March 20, 2025

**RE: CPUC Data Request #4 for PG&E's Moraga to Oakland X 115 Kilovolt Rebuild Project
(A.24-11 -005)**

CPUC Data Request Item AES-4

Figure 1
DR4 AES-4b Existing and Proposed View
 Moraga-Oakland X 115 kV Rebuild Project
 Pacific Gas & Electric Company

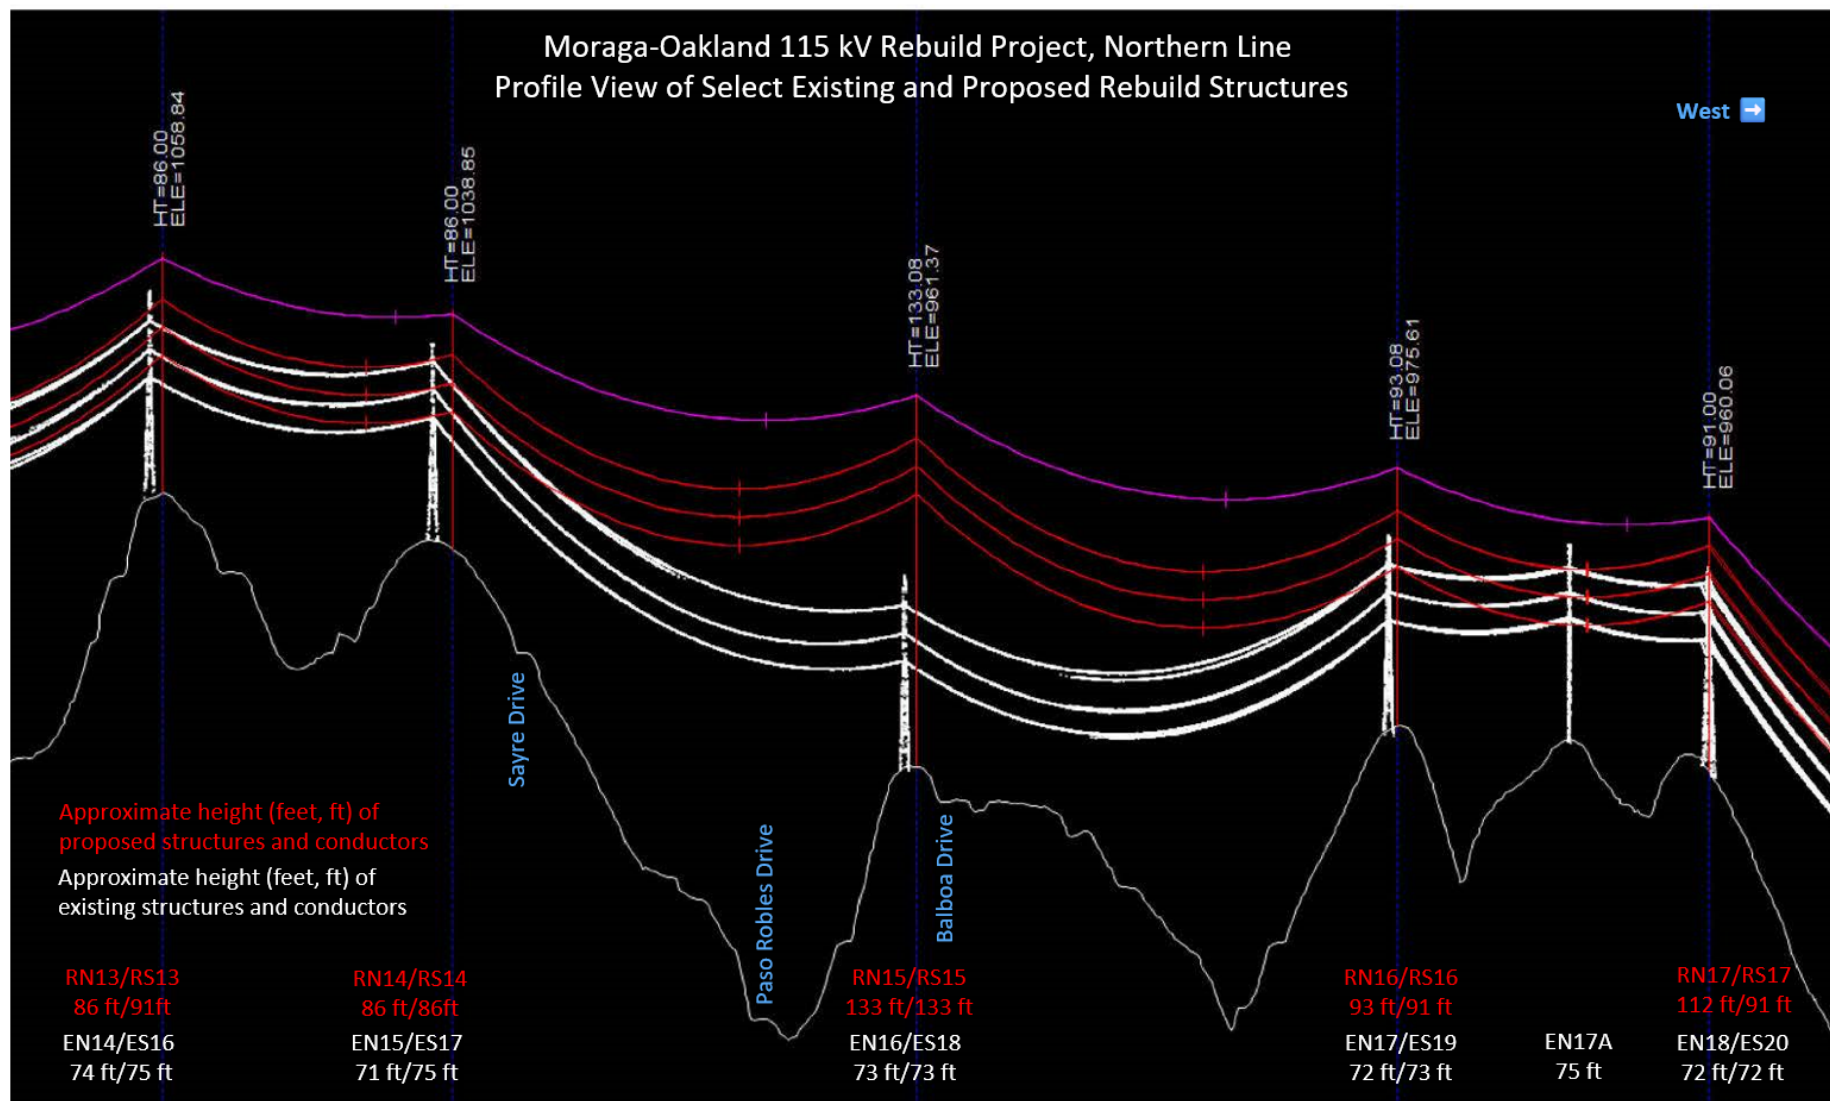
AES-4 PEA Figure 5.1-8B presents a visual simulation that captures an inline view of two taller replacement lattice steel poles (LSPs) (Structure Nos. RN15 and RS15 - 133 feet tall each) in the foreground primary cone of vision of eastbound travel on Balboa Drive/West Circle and two taller LSPs and two tubular steel poles (TSPs) farther upslope that would replace six existing LSTs ranging in height from 67 feet to 86 feet. The foreground pair of replacement structures would be substantially taller than the existing structures (82% increase in structural heights).

- a. Please explain the need for PG&E's proposed increase of heights to Towers RN15/RS15 as no adjacent towers are proposed for removal and the span length would be similar to the existing line.
- b. With the addition of a pair of interset towers upslope from RN15/RS15 and approximately mid-way to the next pair of structures (RN14/RS14), what would the resulting tower heights be for the interset towers, Towers RN15/RS15, and Towers RN14/RS14?
- c. Please provide information on the necessity for and location of cranes and any temporary road closures, if needed to support installation of interset towers upslope of RN15/RS15.
- d. How many trees would need to be replace and/or trimmed with the placement of interset towers in this location?

a. Please explain the need for PG&E's proposed increase of heights to Towers RN15/RS15 as no adjacent towers are proposed for removal and the span length would be similar to the existing line.

The proposed heights of rebuild structures RN15/RS15 are based on construction constraints and safety and design requirements. A profile view of the existing and proposed structures being discussed in this response is provided in Attachment 1, Figure 1. This figure shows the topography of this section of the project alignment with residential roads appearing as "benches" in the hillside.

Safety and design considerations for the proposed heights of RN15/RS15 include the following items:

- RN15/RS15 will be lattice steel poles (LSP) which have a narrower profile than the existing lattice steel towers (LST). These types of structures were selected because the RN15/RS15 location is accessed from the adjacent narrow, windy Balboa Drive. LSP structures can be constructed in smaller sections that are transported and lifted into place with smaller transport vehicles and construction equipment which can navigate the narrow, windy road.

- Both sets of structures to either side of RN15/RS15 are at higher elevations, as shown in Figure 1. The conductors on the LSPs are held by insulators that are suspended, or hang from, the end of each structure arm. If RN15/RS15 were designed with shorter structure heights, uplift conditions would occur that would push the suspended insulators upwards, putting stress on the conductor, insulators, and their connections. The proposed structure height avoids uplift conditions.

- To meet current design standards, the proposed insulators are longer than existing necessitating taller structures to achieve the required distance above the ground for safe operation.

- RN15/RS15 are positioned at a slight angle in the line. An angle causes the outside insulator to swing closer to the supporting arm under wind conditions. A taller structure reduces the insulator swing and creates a safer operating condition.

- To accommodate forecasted load growth, the proposed conductor type is a larger size than existing. The proposed structure height is approximately 5 feet taller to accommodate the conductor tension required for the proposed conductor type.

- West of RN15/RS15, the existing structure EN17A between EN17/ES19 (RN16/RS16) and EN18/ES20 (RN17/RS17) is proposed to be removed. To accommodate this removal, RN16/RS16 would be 93 ft/91ft respectively, taller than the existing 72 ft/73 ft existing structures to meet required clearances and other design standards. Those increased heights to the west contribute to RN15/RS15s increased heights.

- Additionally, while not a CEQA issue, the proposed design adds 10 feet above the necessary height to increase the distance of the line from the surrounding residential land use per the project's electromagnetic field (EMF) field management plan. This design element was proposed in consideration with the CPUC's policies governing the mitigation of EMF effects using low-cost and no-cost measures.

In order to reduce the height of proposed structures at this location PG&E would need to install either a dead-end TSP or dead-end LST, which can withstand greater uplift conditions. Balboa Drive limits the length of transport vehicles for rebuild structure lengths and construction equipment size. The longer transport vehicles needed to install a dead-end TSP or dead-end LST cannot fit around the curves of Balboa Drive. PG&E is restricted from using helicopters to transport structure materials to the work site due to close proximity to habitable structures.

Figure 2
DR4 AES-4b Existing and Proposed View with Intersect Structures
 Moraga-Oakland X 115 kV Rebuild Project
 Pacific Gas & Electric Company

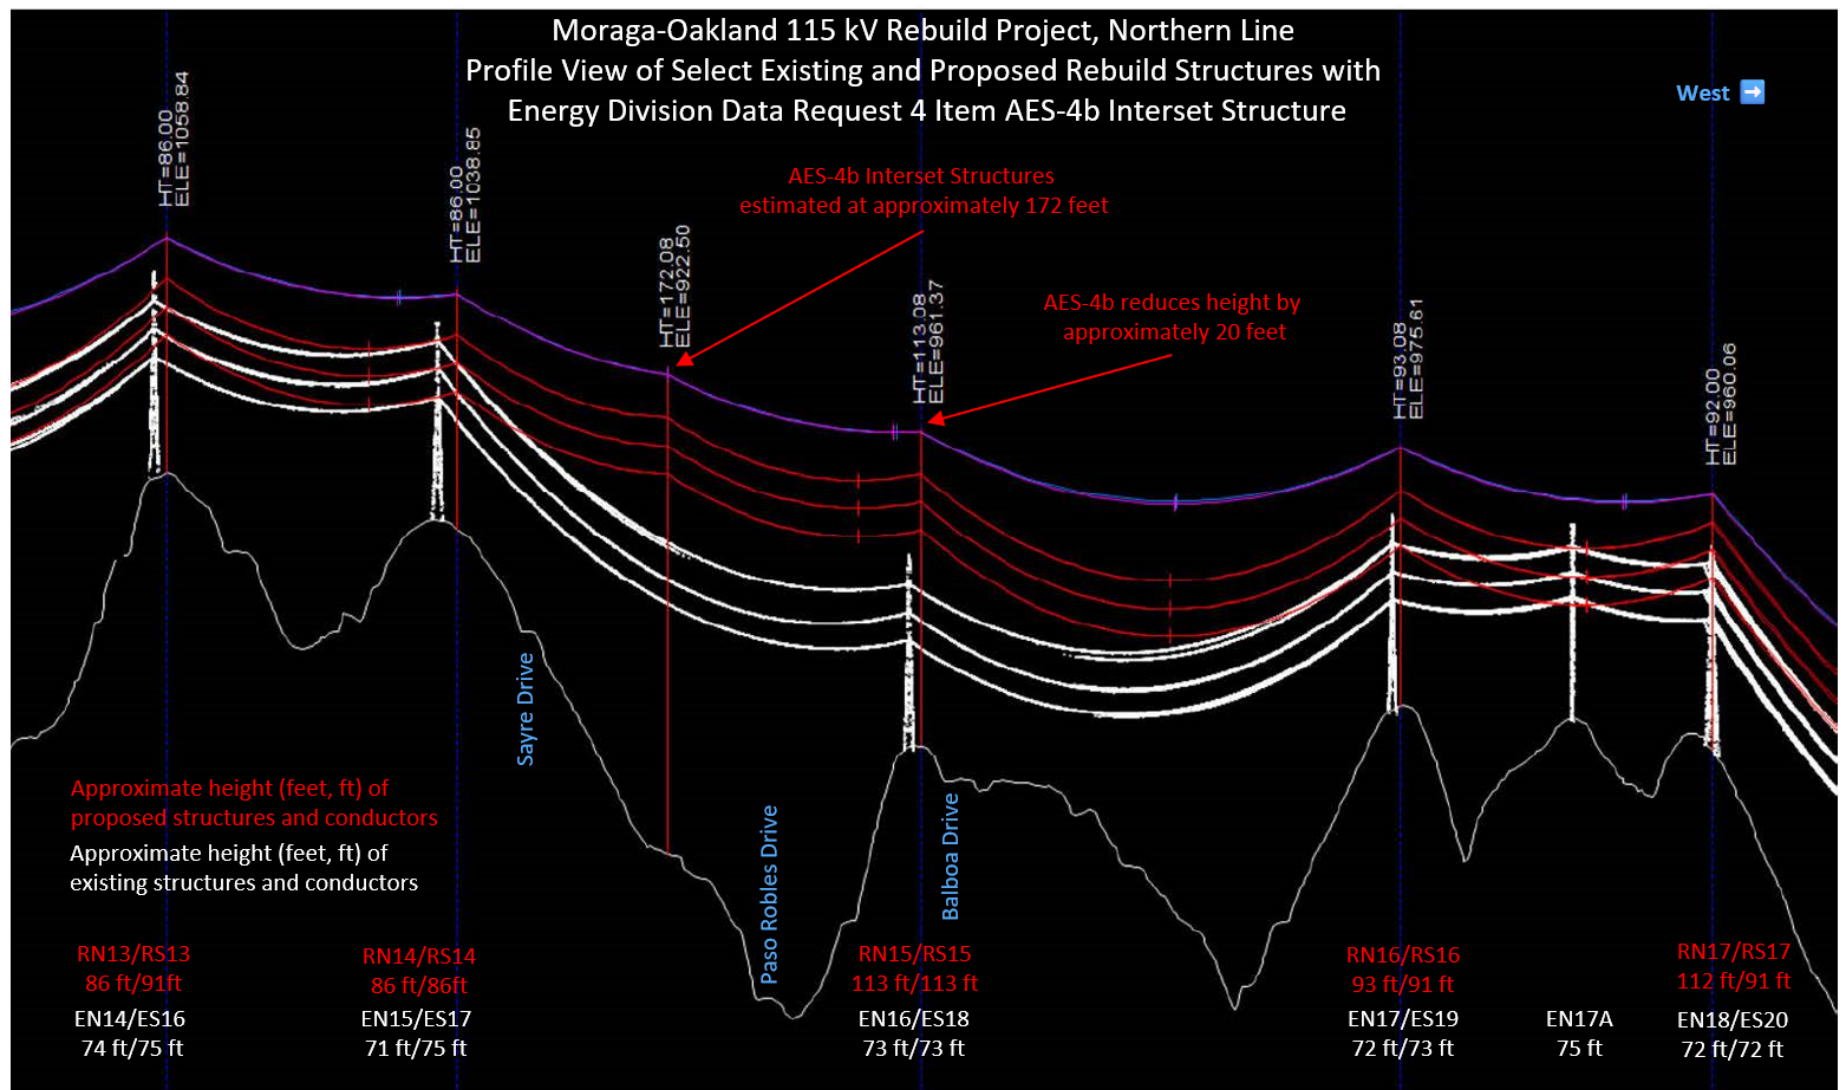
b. With the addition of a pair of interset towers upslope from RN15/RS15 and approximately mid-way to the next pair of structures (RN14/RS14), what would the resulting tower heights be for the interset towers, Towers RN15/RS15, and Towers RN14/RS14?

Because of the slope and topography in that area, interset structures between RN14/RS14 and RN15/RS15 potentially only would reduce the height of the RN15/RS15 by approximately 20 feet (from approximately 133 feet to approximately 113 feet). The interset dead-end structures, likely TSPs or LSTs, would be approximately 172 feet if located at latitude 37.83286218 and longitude -122.19689455, between Paso Robles Drive and Sayer Drive, approximately. See Attachment 1, Figure 2 for a profile view with that interset structure.
